**SUBJECT: Walnut Energy Center Project (02-AFC-4C)
Staff Analysis of Proposed Modifications to the Back-up Water
Supply**

WALNUT ENERGY CENTER (02-AFC-4C)
Petition for Modification of Back-up Water Supply
EXECUTIVE SUMMARY
Prepared by: Joseph Douglas
June, 2013

WALNUT ENERGY CENTER (02-AFC-4C)
Petition for Modification of Backup Water Supply
Soil and Water Resources Analysis
Prepared by: Abdel-Karim Abulaban
June 2013

Soil & Water Resources Figure 1
Duration and Frequency of Interruptions of City of Turlock WWTP Recycled Water Supply to WEC for the period January 2010 – December 2011

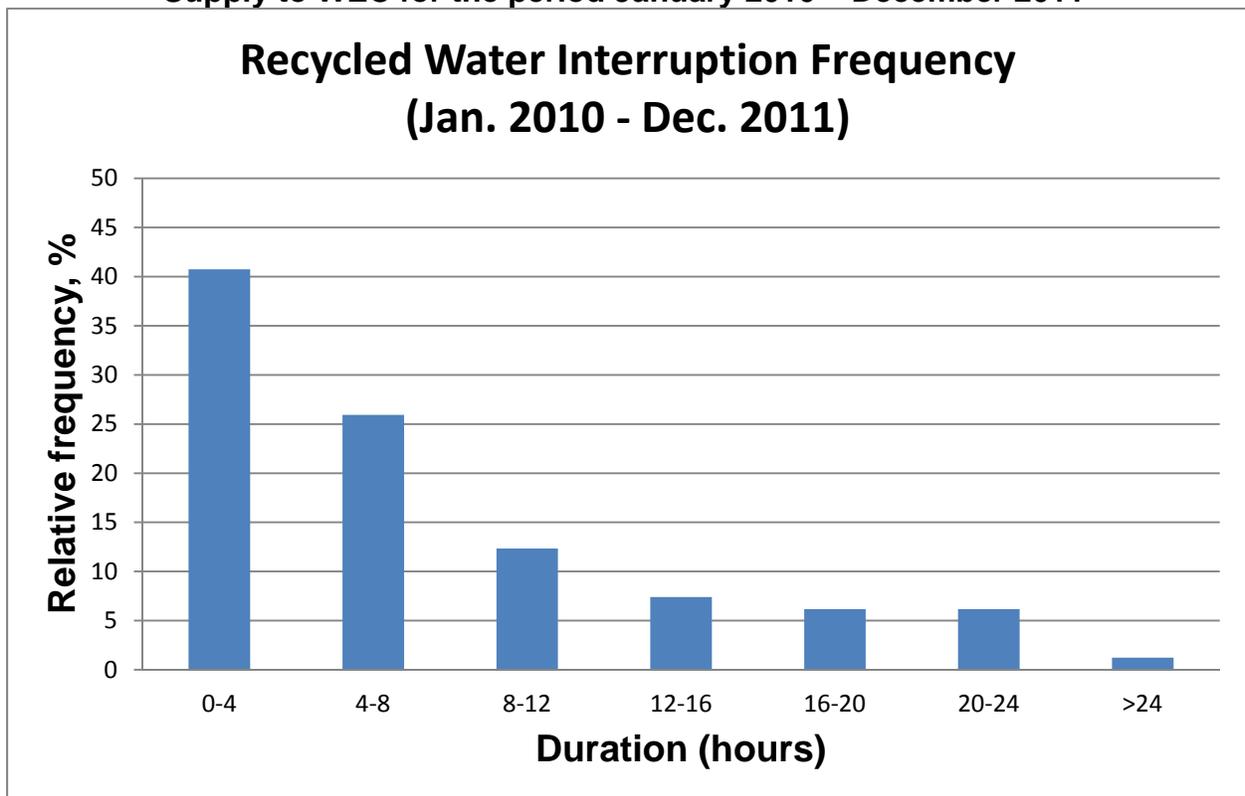
analysis. The frequencies are depicted graphically in **Soil & Water Resources Figure 1**. About 41 percent of the interruptions lasted less than 4 hours, 67 percent of the interruptions lasted less than 8 hours, while roughly 80 percent lasted less than 12 hours. The median duration of the interruptions was 6.2 hours. There has been only one incident where the interruption lasted more than 24 hours, and that could have been due to high turbidity in the outflows caused by heavy rain that brought in a heavy load of fine material in the inflows to the WWTP.

Staff has not received reports showing the actual durations of those recent interruptions, which is why those interruptions have not been included in the data for **Soil & Water Resources Figure 1**.
